Palaterra Subdivision Addition 2
Summary of Community Meeting
March 4, 2021

Subject: Proposed Palaterra Subdivision Addition 2 plat, with variance for intersection distance

**A Preliminary Plat of:
Lots 1-12,
Palaterra Subdivision
Addition 2, with Variance**

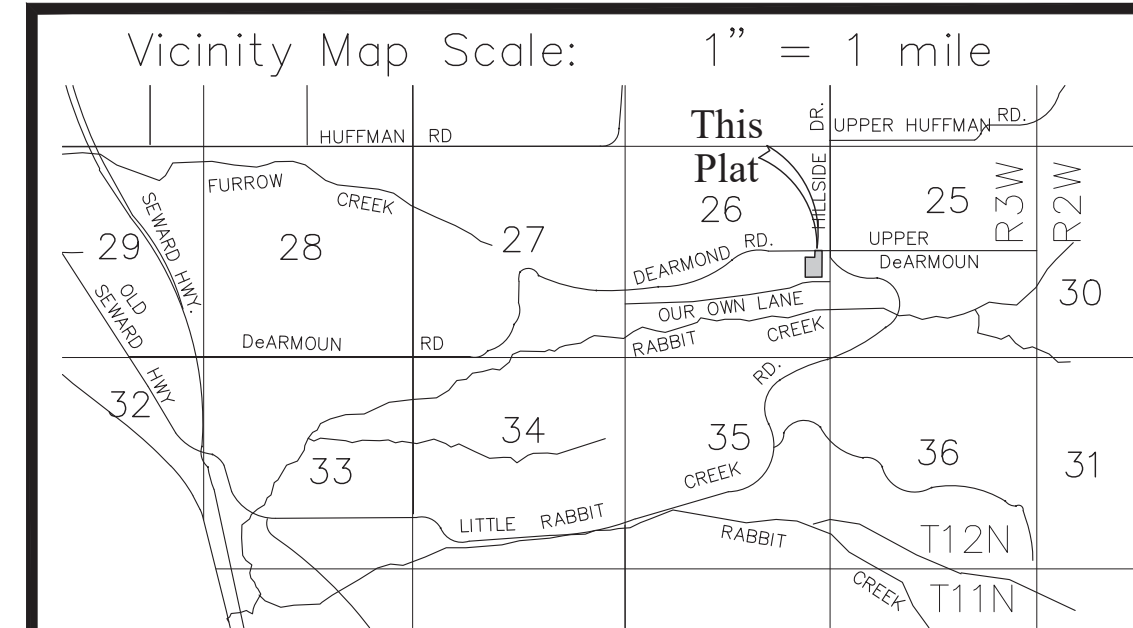
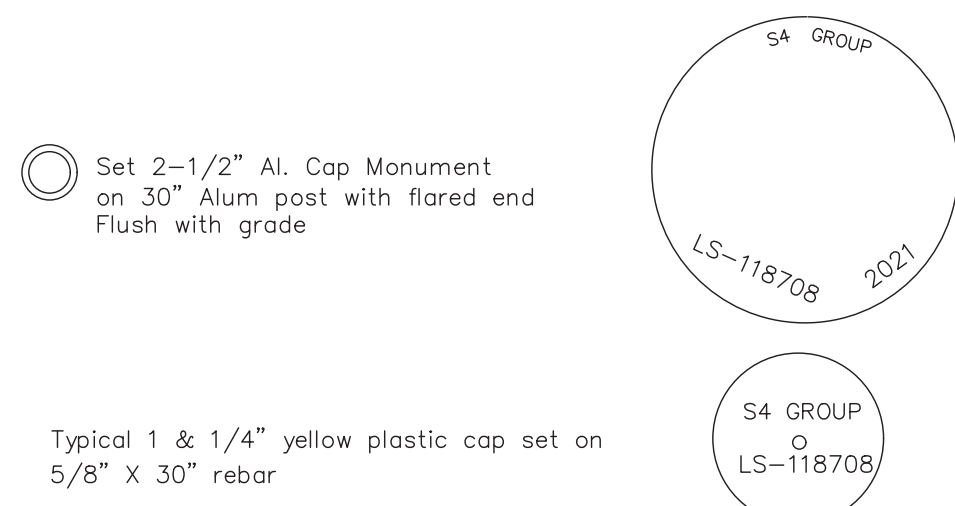
Q: (In regards to the cul-de-sac intersection with De Armoun, from the current resident of Collier Subdivision Lot 1) Why does the road directly abut the Collier Subdivision Lot1 lot line? Can it be moved farther away from said property?

Q: Will you be removing vegetation from the southern slope of Lot 5, 6, & 7? I have concerns about erosion and flooding.

Q: On previous plats notes have been added that no soil movement or modification to drainage patterns could occur that would impact nearby rights-of-way or neighboring property. I do not see such a note on this plat and would like one to be added.

Q: What is the drainage plan for the road/access?

Q: Will there be enough room for snow along the cul-de-sac access?

A: The cul-de-sac access ROW is placed in such a way because there is an existing house on proposed lot 12. Said house also has a septic system, which the ROW has to be 10 feet away from the nearest standpipe. Both of these factors affect the access position.

A: There are no plans to clear or develop the southern slope of the project location. Lots 5, 6, & 7 are very large to allow ample room to develop at the northern ends of the proposed lots.

A: The plat notes you are seeing are notes laid out and required by the planning department. They will tell us what notes need to be added to the plat. I will record your request for our submission though.

A: A drainage plan will be done prior to the plat recording, and requirements will have to be met so as to not negatively affect any neighbouring properties.

A: This will be a dedicated ROW with a paved road, allowing ample room for snow.
